316 ANNANGROVE ROAD 2155 ROUSE HILL Lot 28 DP 834050

MIXED USE INDUSTRIAL DEVELOPMENT

No.	DESCRIPTION	DATE
01	PRELIMINARY FOR COORDINATION	2/02/2024

DRAWING TITLE:
SECOND FLOOR PLAN

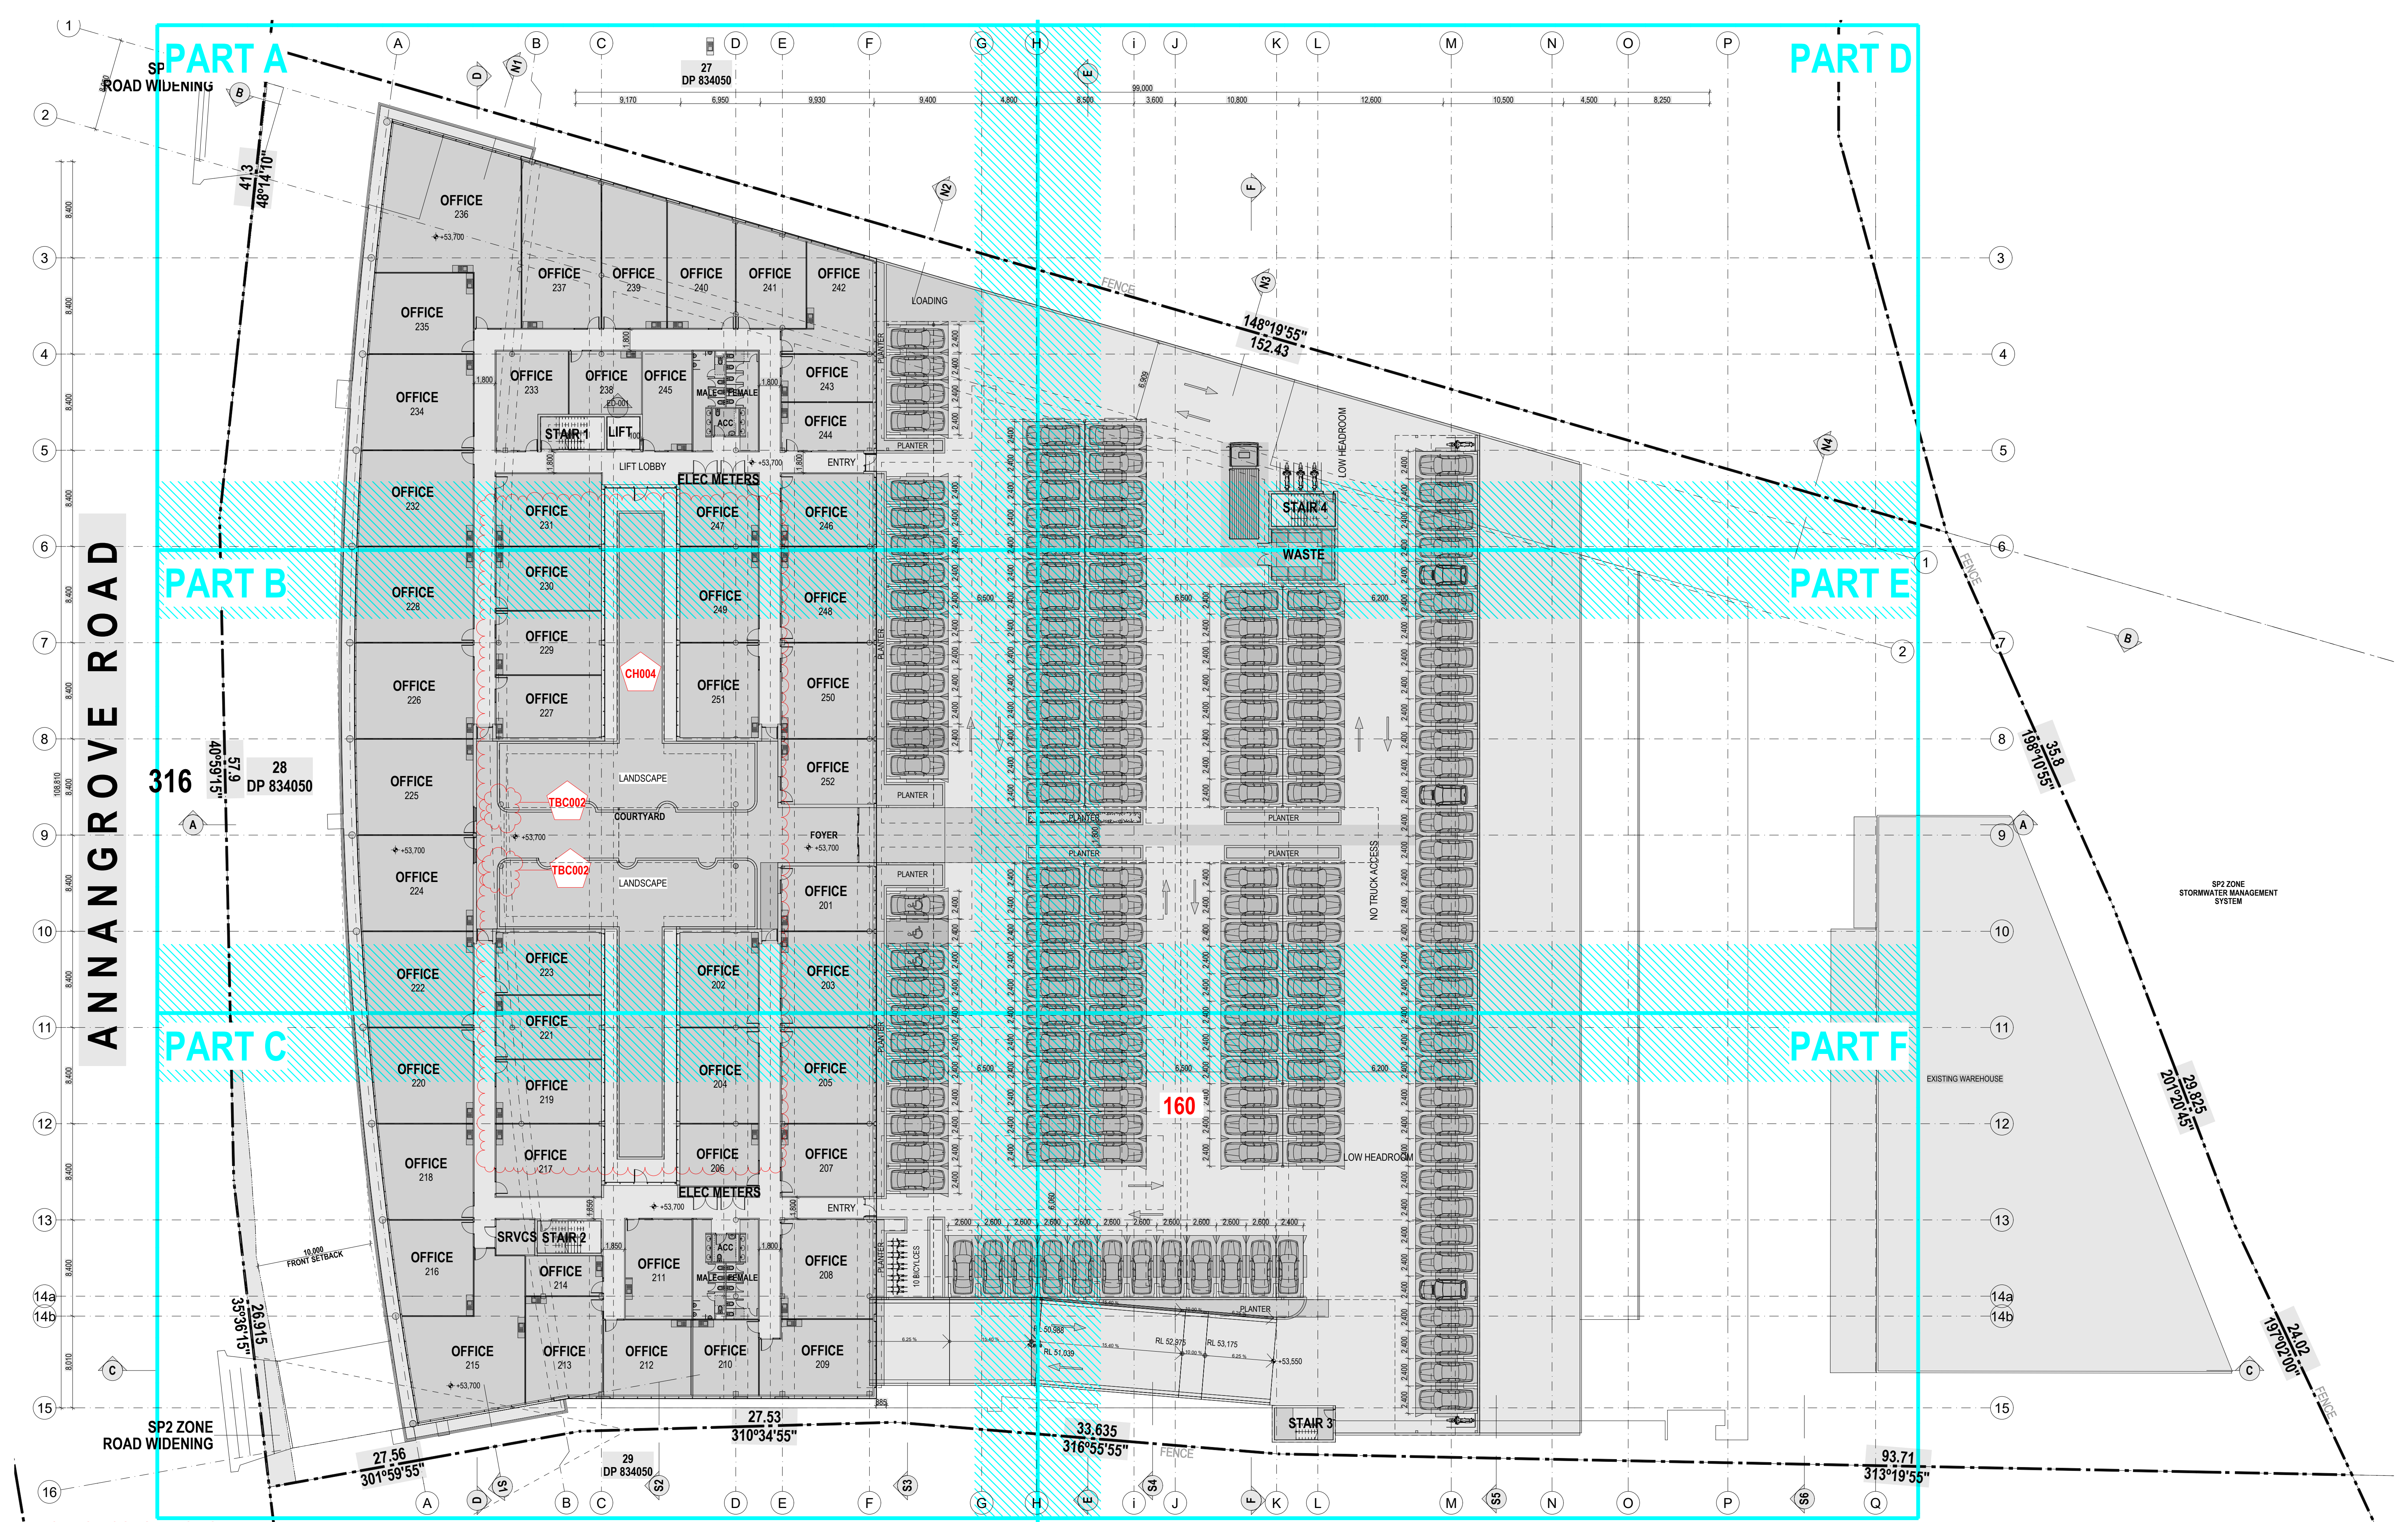
CHANGES
CH004 ROOF GARDEN DESIGN UPDATED
CH005 OFFICE NUMBERING UPDATED
CH014 AREAS REMOVED FROM PLANS
TBC002 RW-COLUMN TO BE COORDINATED
